SUBJECT: Forwards response to request for addl info to facilitate NRC
 review of CEN-259, "An Evaluation of Natural Circulation of
 Cooldown Test Performed at San Onofre Nuclear Generating
 Station."

Subject: Docket Nos. 50-361 and 50-362
San Onofre Nuclear Generating Station
Units 2 and 3

RESPONSE TO NRC REQUEST FOR ADDITIONAL
NATURAL CIRCULATION INFORMATION

Figure 2

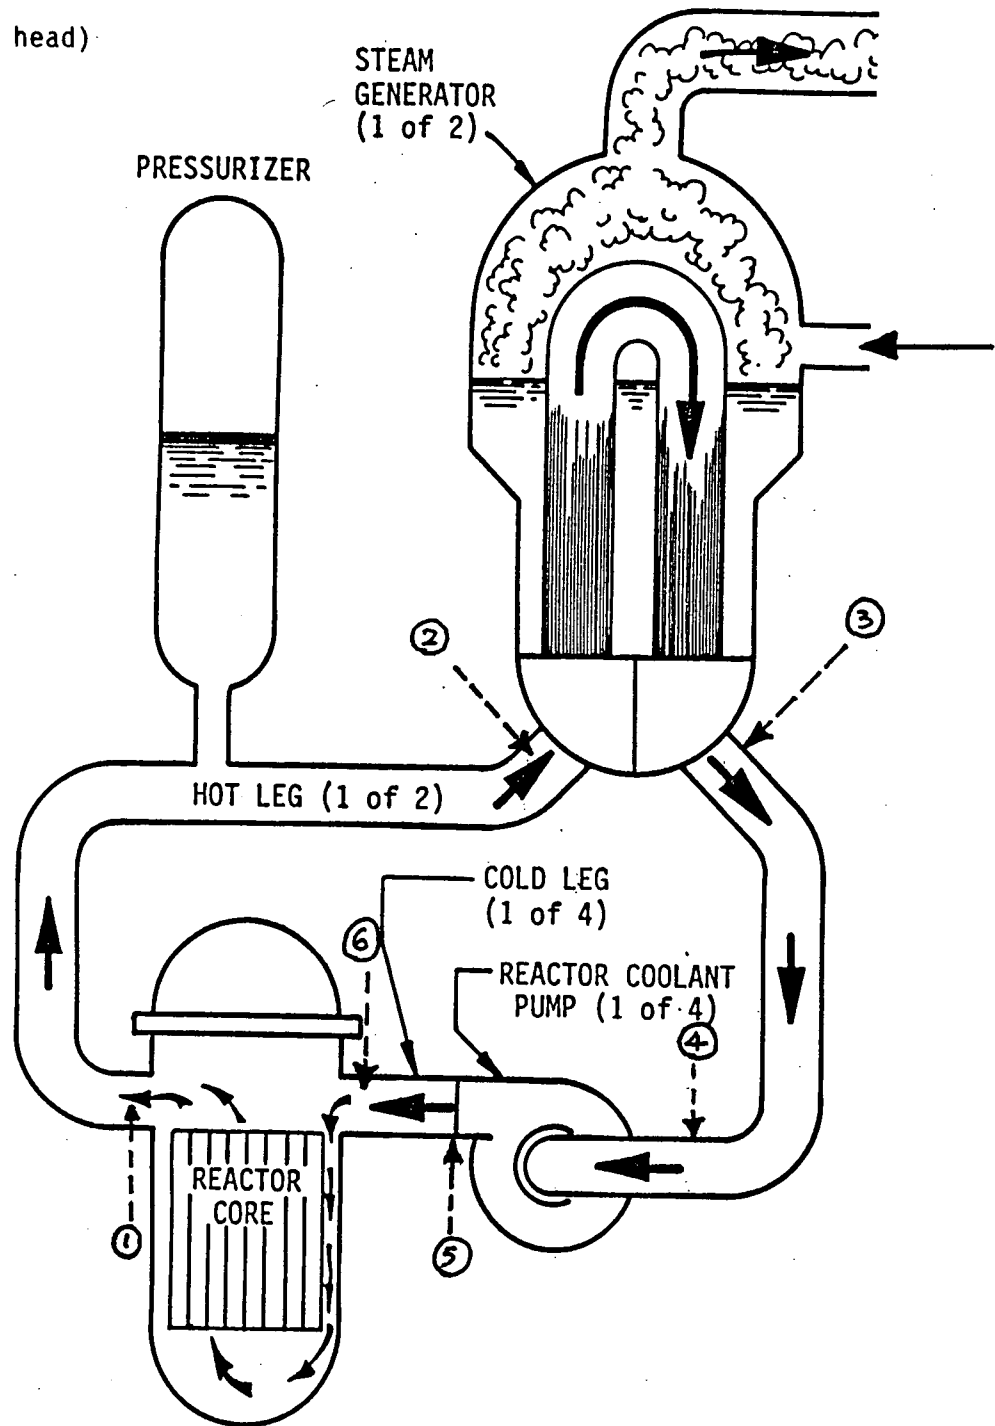
3. FSAR Table 4.4-4 shows delta pressure for the vessel. Similar information regarding delta pressure in other components of the RCS outside the vessel is needed (such as delta pressure from the vessel upper plenum to the vessel outlet nozzle to the steam generator inlet nozzle, from the steam generator inlet nozzle to the outlet nozzle, from the steam generator outlet nozzle to the pump, and from the pump to the vessel inlet nozzle).

See Figure 2 of this enclosure.

$\Delta P_{1-2} = 0.5 \text{ psi}$
 $\Delta P_{2-3} = 47.0$
 $\Delta P_{3-4} = 5.0$
 $\Delta P_{4-5} = 96.7 \text{ (pump head)}$
 $\Delta P_{5-6} = 0.8$
 $\Delta P_{6-1} = 43.4$

Figure 4

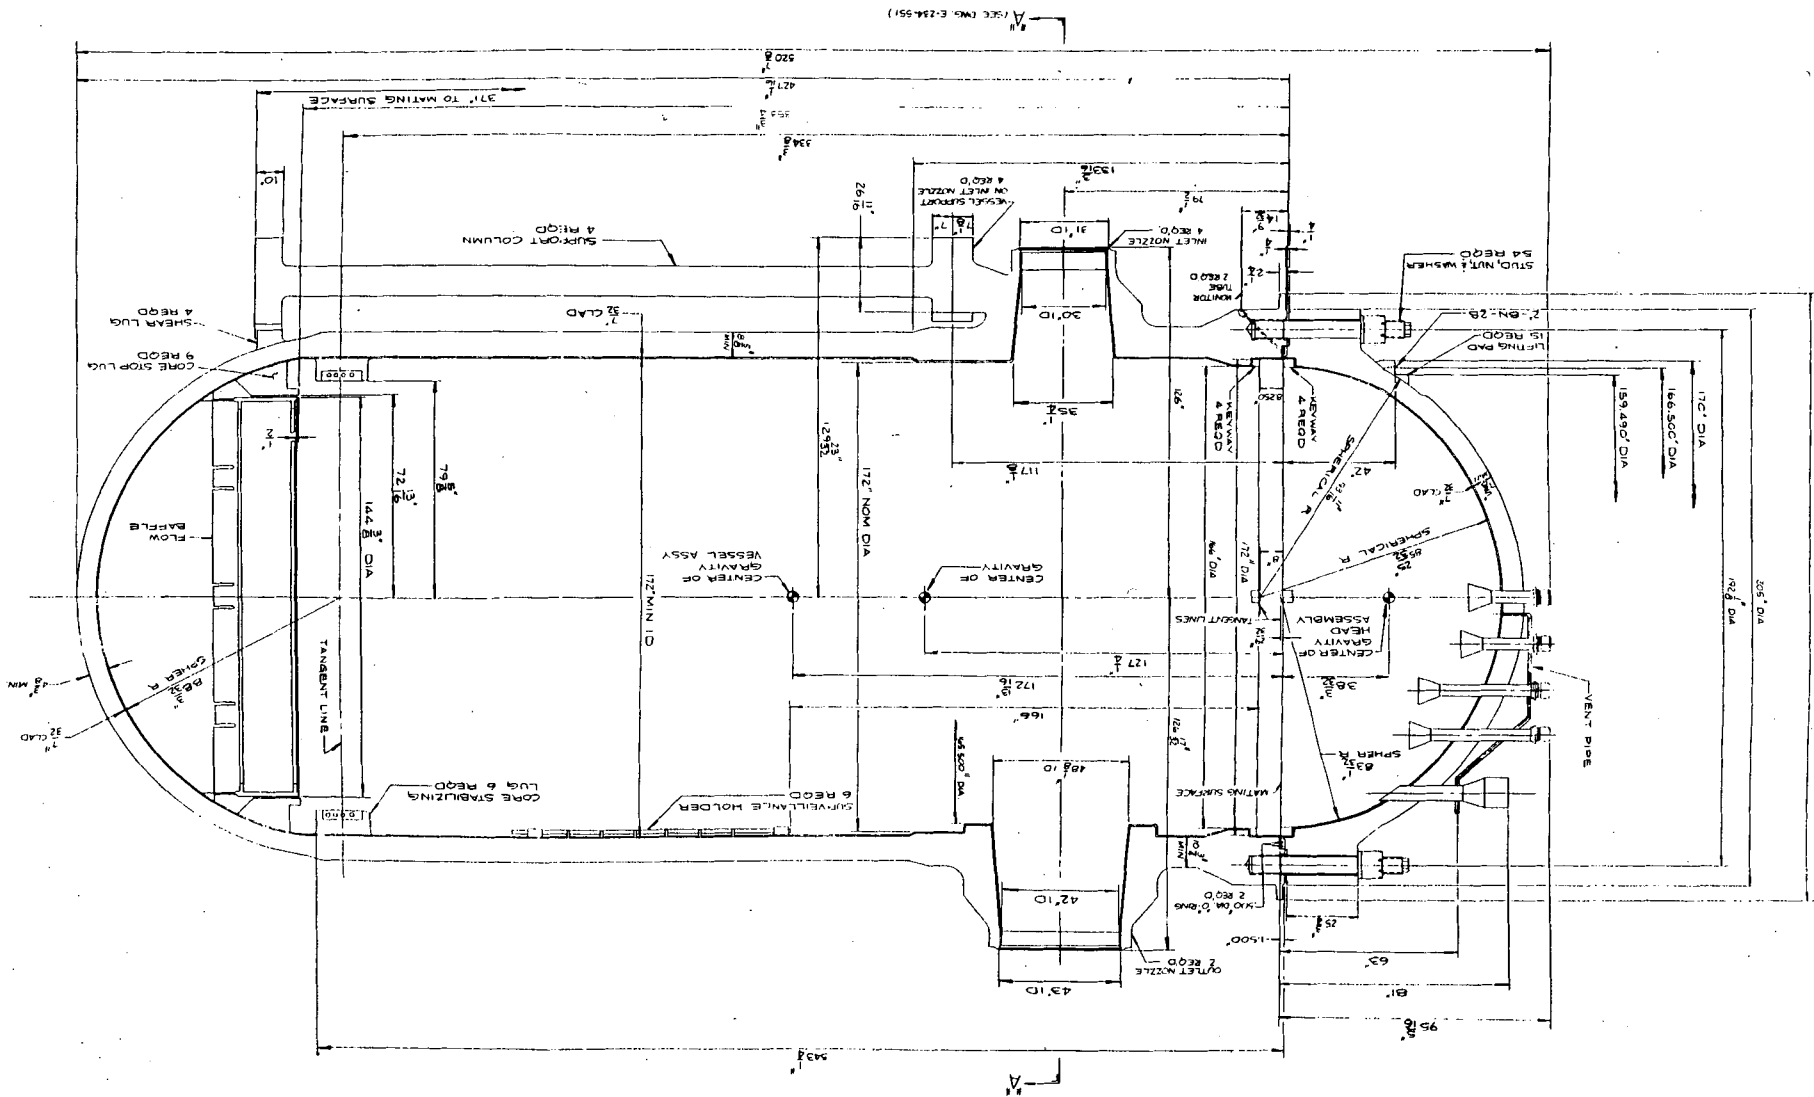
7. Provide detailed geometric information on the upper head including the thickness, surface area and material of the upper head hemisphere, number of the CEDM drive trains, material and structure of CEDM drives (length, penetration into the upper head, cross-sectional geometry), number of guide tubes, material and structure of the guide tubes length, penetration into the upper head and cross-sectional geometry), and structure and material of the upper core support plate.

Provided as an attachment to this enclosure are the applicable sections of the FSAR which provide information regarding reactor vessel materials, the number of CEA's and guide tubes and details regarding the upper core support plate. A reactor vessel arrangement diagram (Figure 3) has been provided to show all reactor vessel dimensions. Figure 4 details the number of reactor vessel head penetrations and their locations. A diagram of a control element drive mechanism has also been included (Figure 5).
